Subject: Response to Request for Additional Information (RAI) Letter No. 7 –
Exelon Early Site Permit (ESP) Application for the Clinton ESP Site
(TAC No. MC1122)

Re: Letter, U.S. Nuclear Regulatory Commission (N. V. Gilles) to Exelon
Generation Company, LLC, (M. Kray), dated July 26, 2004, Request for
Additional Information Letter No. 7 – Exelon Early Site Permit
Application for the Clinton ESP Site (TAC No. MC1122)

Enclosure: Response to RAI 2.5.1-1 through 2.5.1-5 (and associated attachments)
Response to RAI 2.5.2-1 through 2.5.2-7
Response to RAI 2.5.4-1 through 2.5.4-7

Figure 2.5.1-1-1 Median and Mean Seismic Hazard Curves for 1-Hz Spectral Acceleration Developed Using Alternative Distributions for Characteristic New Madrid Earthquakes

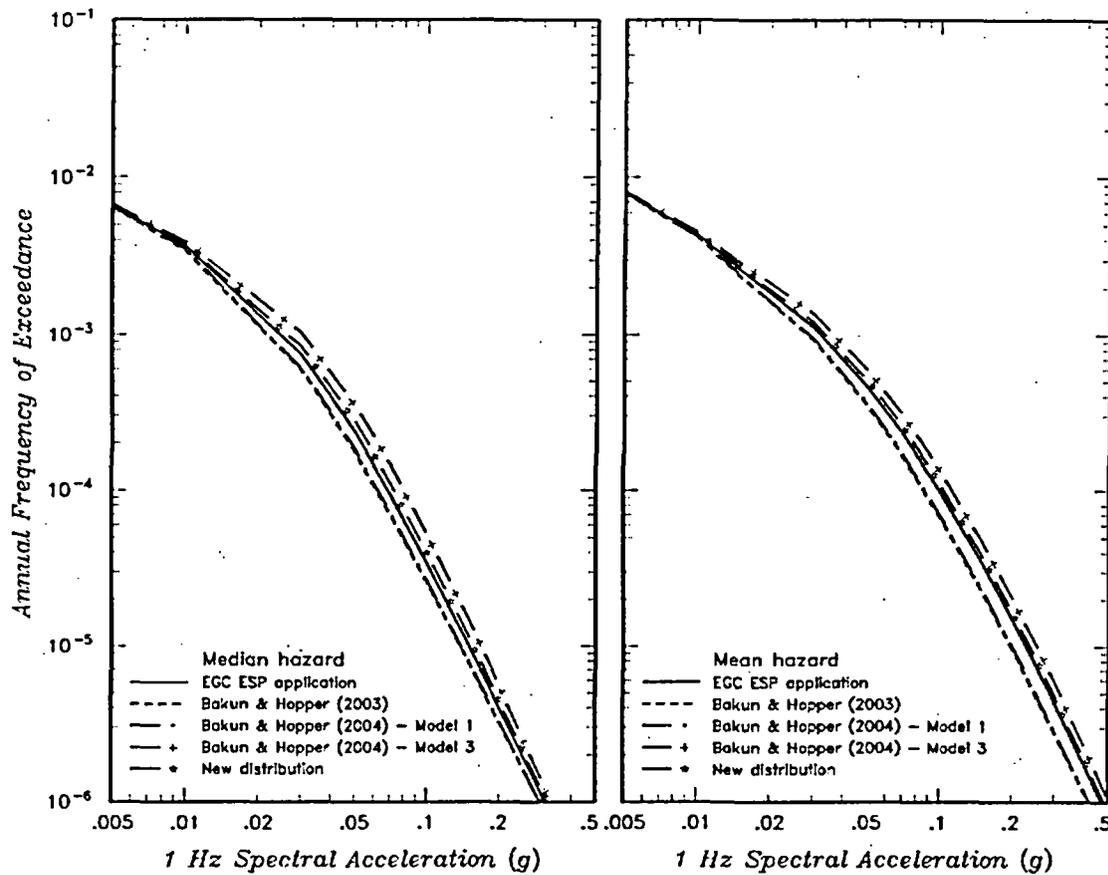
In characterizing the seismic hazard of the New Madrid seismic source zone, SSAR Appendix B (Sections 2.1.5.2.1, 4.1.1.2, and Tables 2.1-3 and 4.1-1) cites the preferred magnitudes of Bakun and Hooper (2003, in press) for the New Madrid main shocks of 1811-12 as M 7.2, 7.1, and 7.4. The work of Bakun and Hooper (2003, in press) has since been revised with magnitude estimates for the 1811-12 New Madrid main shocks as M 7.6, 7.5, and 7.8 (Bakun and Hooper, 2004, Bull. Seism. Soc. Am., v. 94, no. 1, p. 64-75). Please explain what changes these revised magnitude estimates may require in the weights listed in Table 4.1-2 for the size of the expected characteristic earthquake rupture for each fault within the New Madrid seismic zone. In addition, please quantify the effect of the revised magnitude estimates on the hazard at the site by providing a graph showing two long-period (1 Hz) hazard curves, one using the magnitudes of Bakun and Hooper (2003, in press) and the second one using the magnitudes of Bakun and Hooper (2004).

The results of the requested sensitivity analyses to test the impact of different characteristic magnitude assessments on the median and mean rock hazard for 1 Hz spectral acceleration at the EGC ESP Site are shown in Figure 2.5.1-1-1. Five hazard curves are shown on each plot. The curves labeled "EGC ESP application" are taken from Appendix B of the EGC ESP Application. The curves labeled "Bakun & Hopper (2003, in press)," "Bakun & Hopper (2004) - Model 1," and "Bakun & Hopper (2004) - Model 3" were computed using only the indicated magnitude estimates for each of the New Madrid faults. The curves labeled "New distribution" were computed using the suggested updated distribution given in Table 2.5.1-1-2. The new distribution produces approximately 3 to 4 percent higher ground motions at the mean 10^{-4} and mean 10^{-5} hazard levels. These results were computed using the recurrence model and rupture sequences developed in the EGC ESP Application. The effects of alternative recurrence estimates and rupture sequences are presented in the response to RAI 2.5.2-5.
